**ALTERNATE #2
RESOLUTION NO. 14-07**

RESOLUTION OF THE TOWN OF ST. LEO TOWN COMMISSION
APPROVING SPR/VAR #14-A, THE SAINT LEO UNIVERSITY PLANT
OPERATIONS FACILITY WITH CONDITIONS.

**SITE/LANDSCAPE PLAN REVIEW (SPR) STAFF REPORT
SPR/VAR#14-A: Saint Leo University Plant Operations Project
Town Commission Meeting August 11, 2014**

SAINT LEO UNIVERSITY PLANT OPERATIONS PERSPECTIVE RENDERINGS

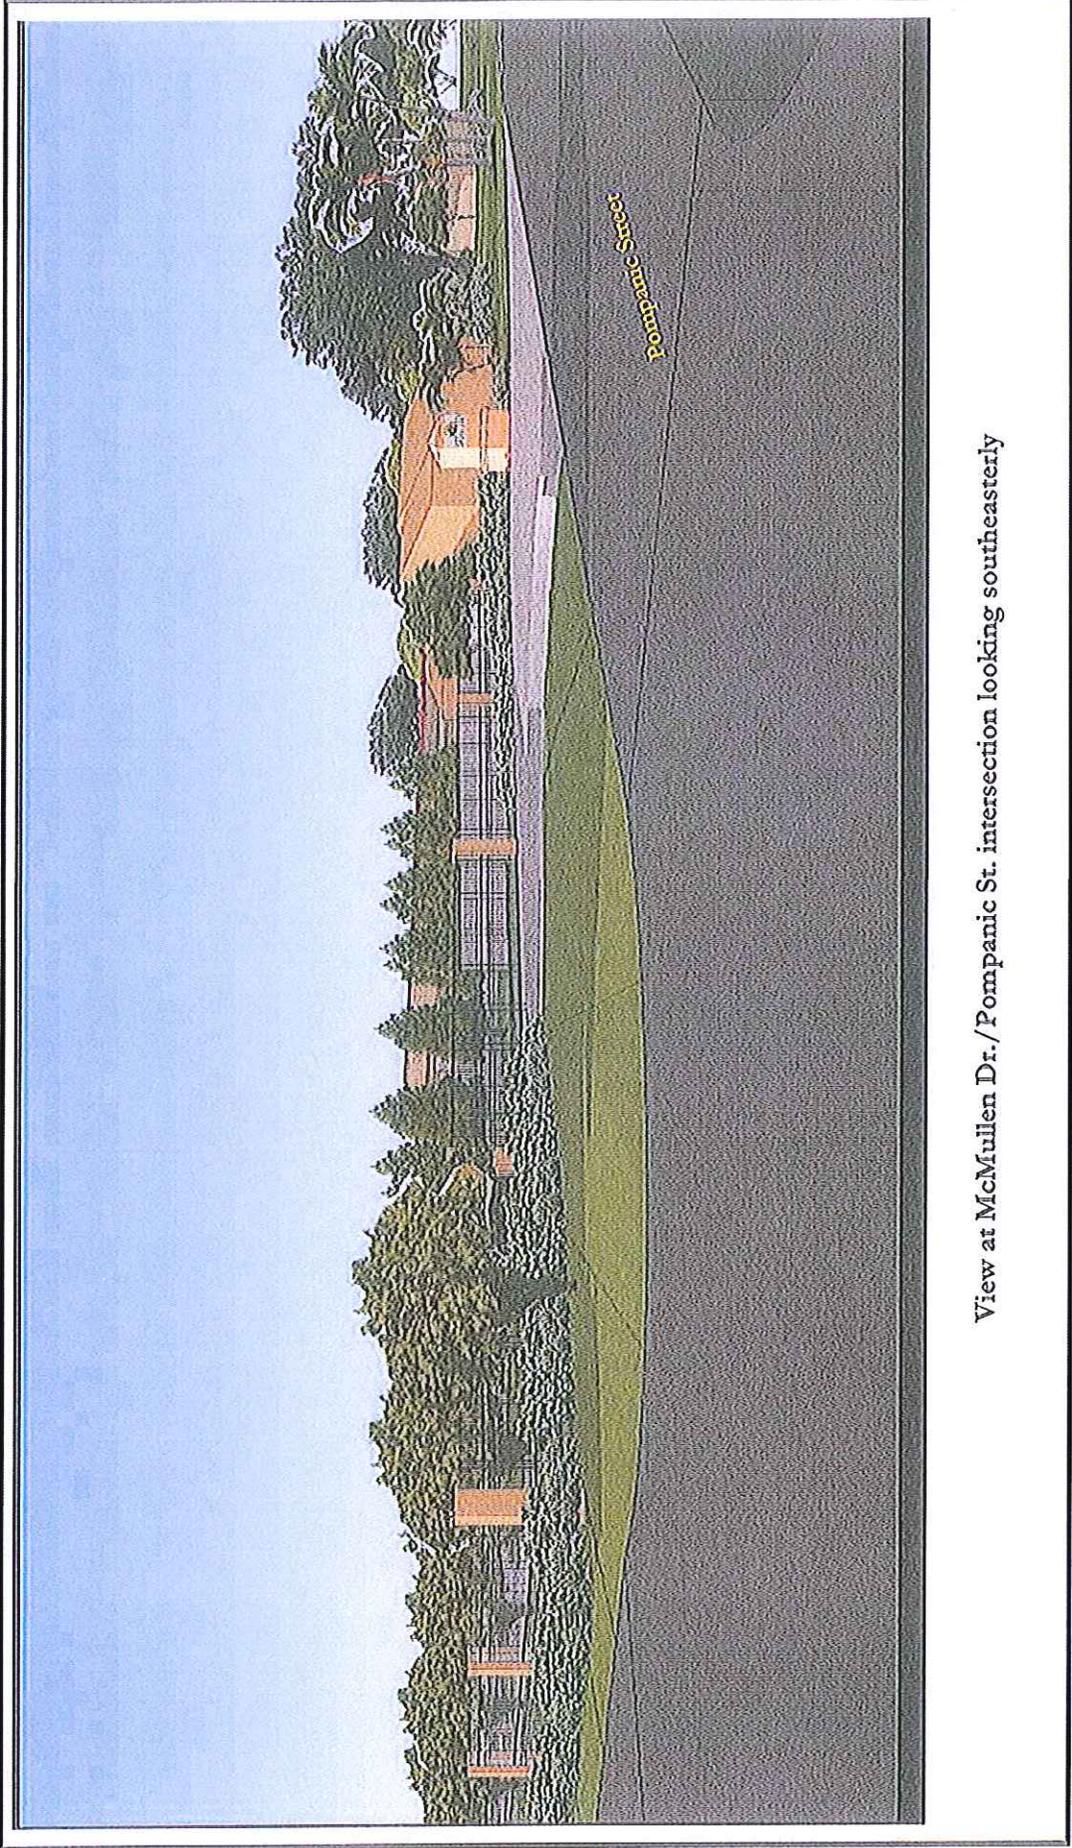
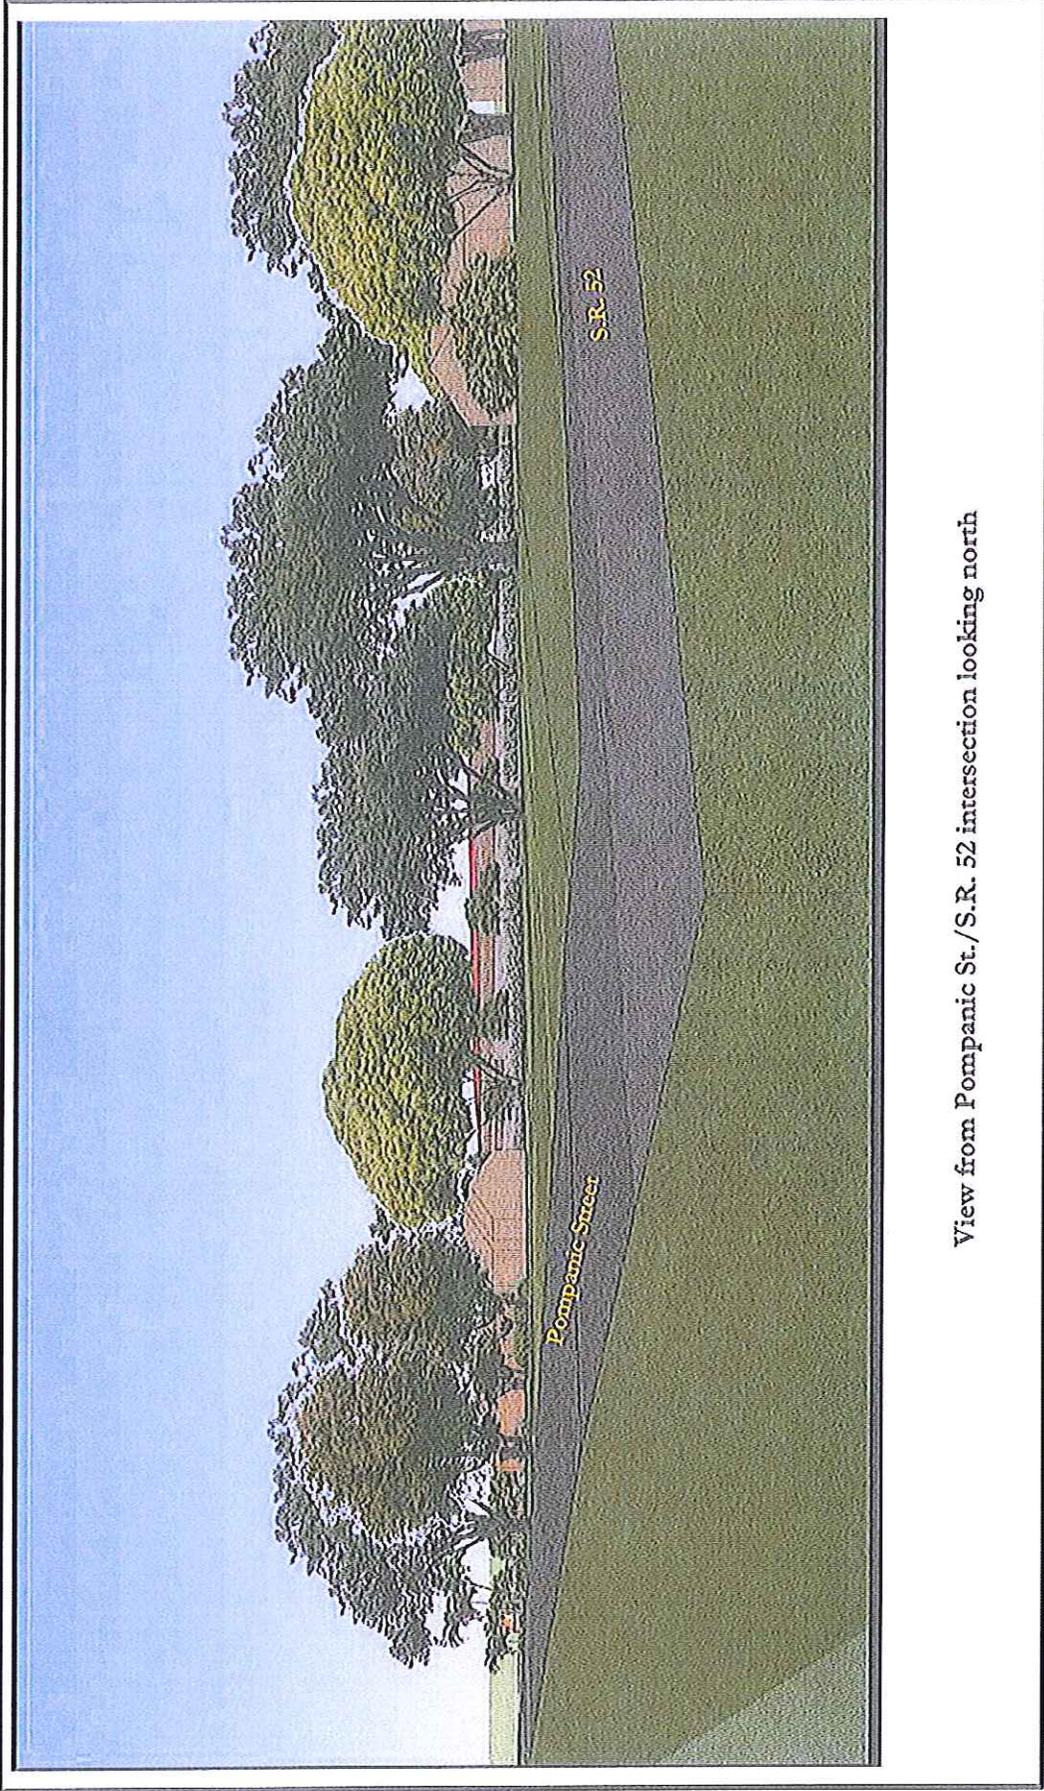
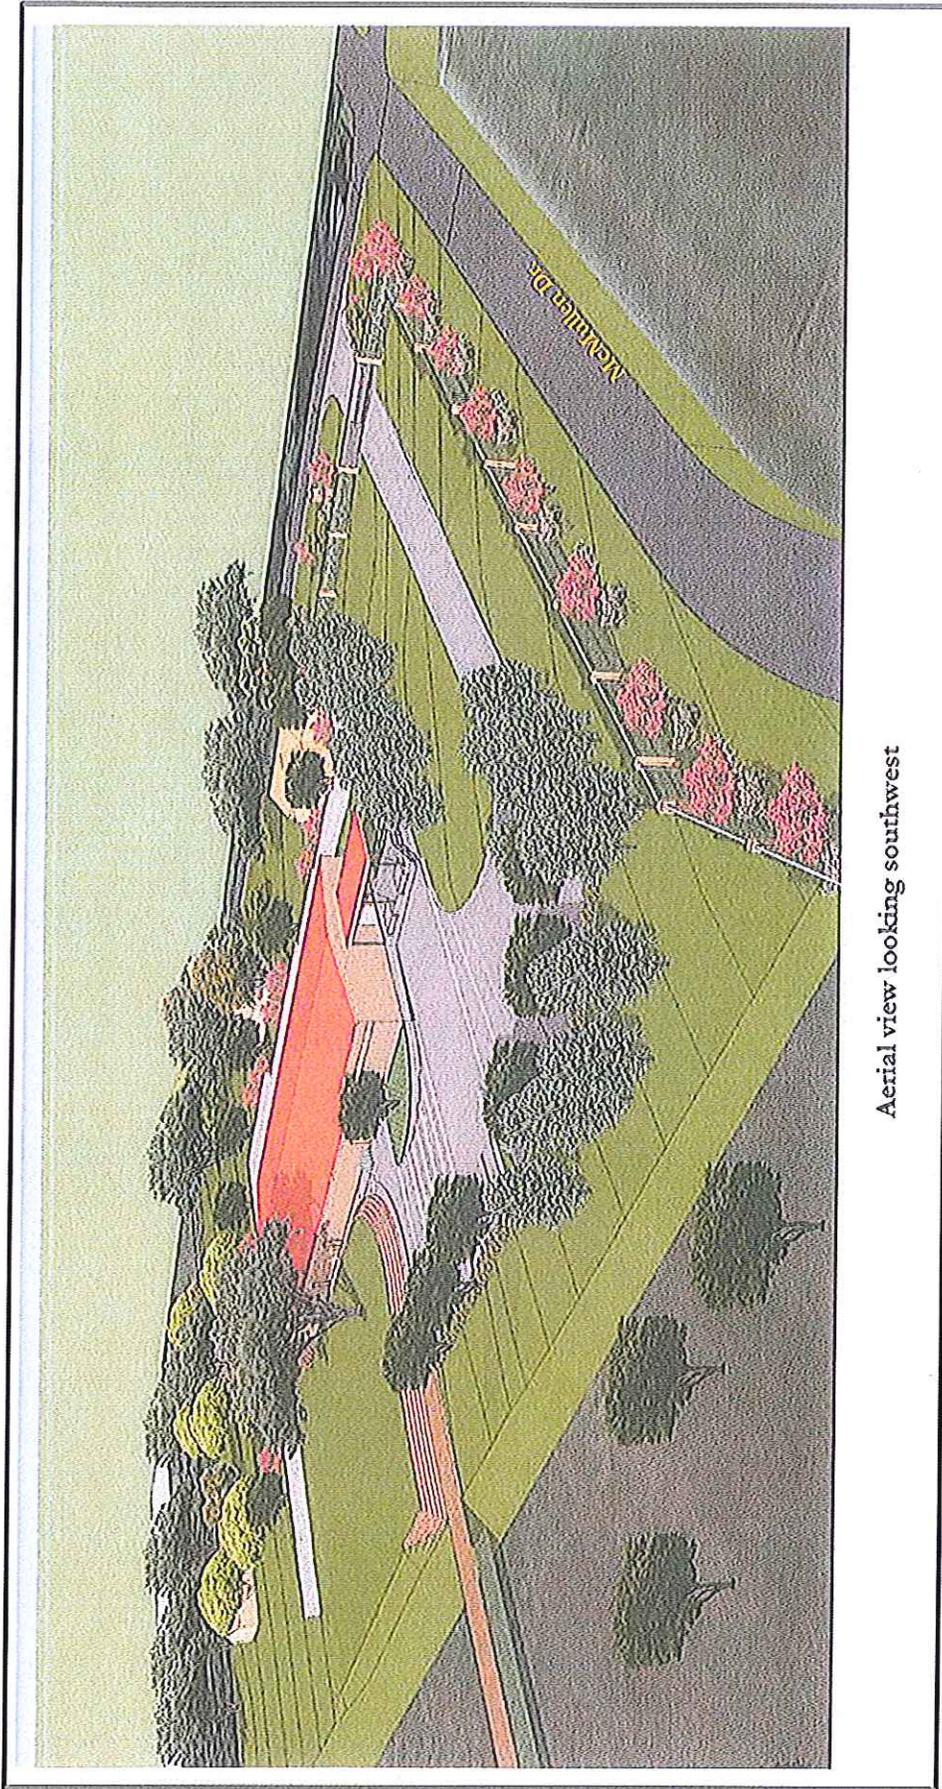
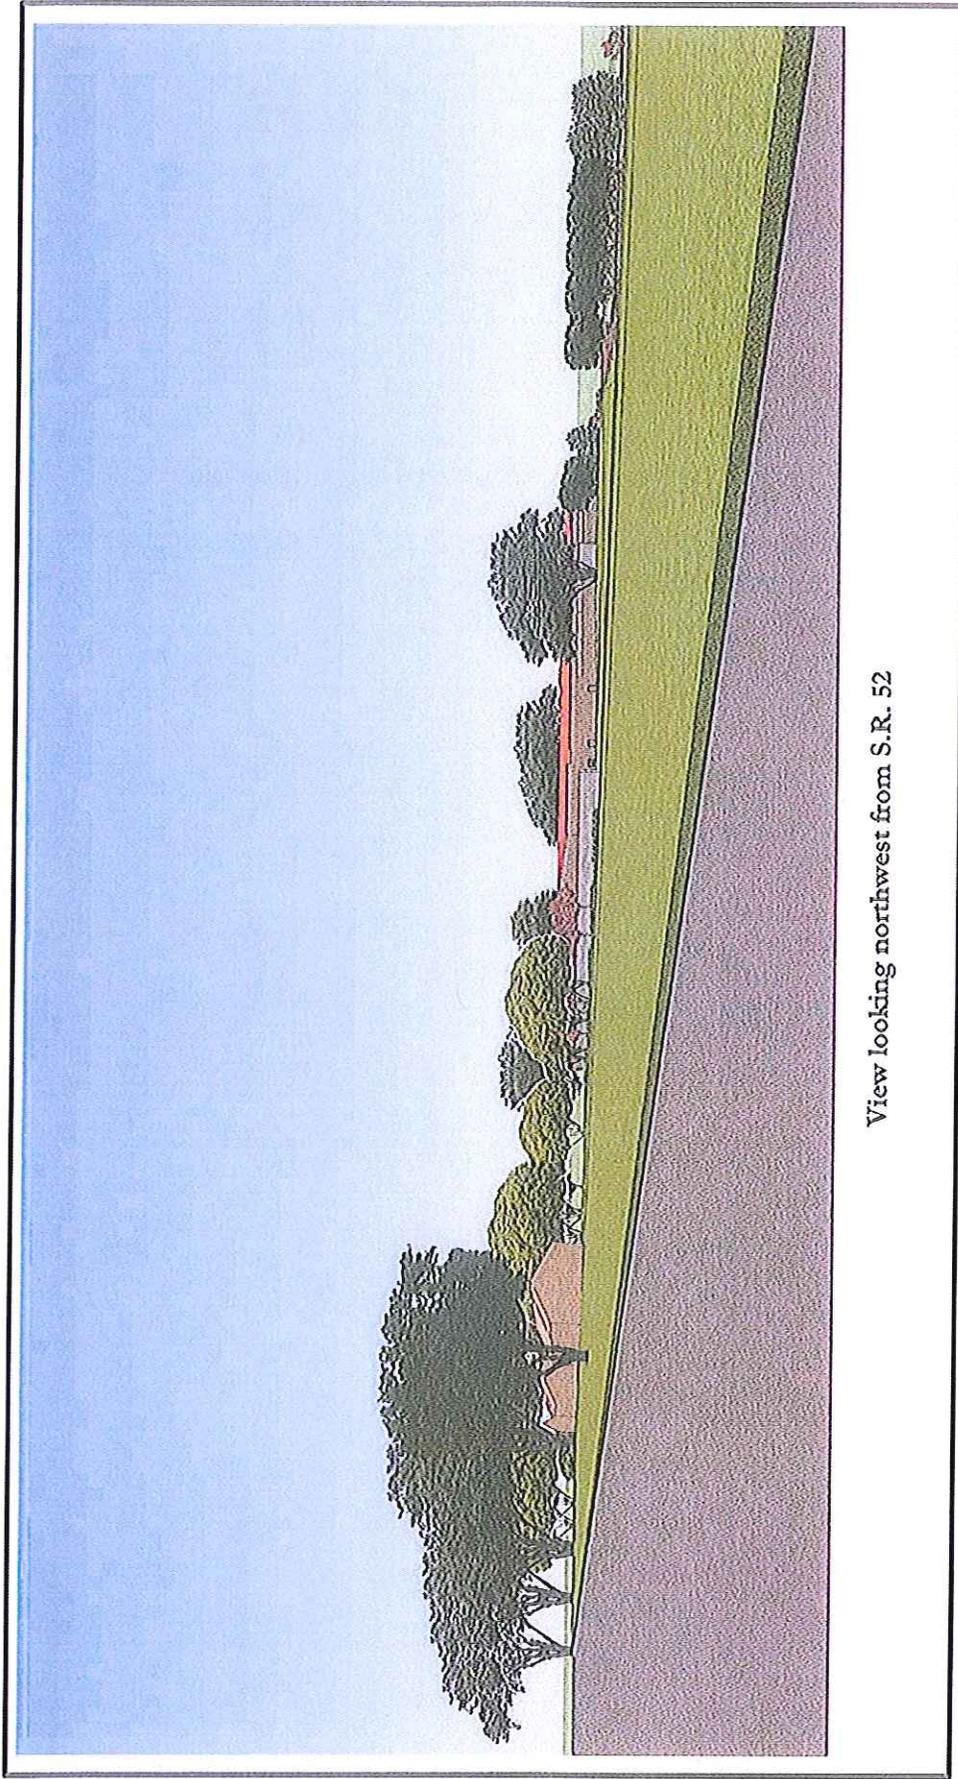
The University has provided perspective drawings illustrating the relationship of the building and proposed landscaping along Pompanic Street and McMullen Drive (Exhibit E). In terms of building design, all newer major campus buildings (since 2010) have been designed in a Mediterranean/Spanish Revival style architecture, which is compatible with the historic Abbey (Spanish/Mediterranean Revival). The building will have a red color metal roof and earhtone color walls as depicted in the perspective drawings (Exhibit E) and elevations (Exhibit E) submitted by the University. Although these colors are consistent with Spanish/Mediterranean Revival, the metal roofing and siding materials are not consistent with other campus architectural building designs and presents more of an industrial design.

The proposed Plant Operations building is located at the northwest corner of the expanded West Campus and will be over 300 feet from S.R. 52 and over 1,000 feet from Lake Jovita. This building will be a metal roofing and siding structure, which is not consistent with other campus architectural building materials and designs. Given its distance from Lake Jovita and S.R. 52, with appropriate landscape buffering around the site there may not be visibility issues. However, it is noted that the topography of the West Campus addition area slopes down from Lake Jovita toward S.R. 52; therefore, given its location, the Plant Operations building will be visible from S.R. 52. The University has provided a perspective drawing illustrating the view from S.R. 52 (Exhibit E).

9. Submit a copy of the SWFWMD permit approval to the Town Clerk prior to issuance of a building permit for the site.
10. Establish a cohesive architectural design for all campus buildings by submitting a revised architectural design of the Plant Operations building that incorporates Mediterranean/Spanish Revival architectural features on the east façade, which is visible from S.R. 52, to be approved by the Town Planning Consultant, unless deemed appropriate to require Town Commission approval.
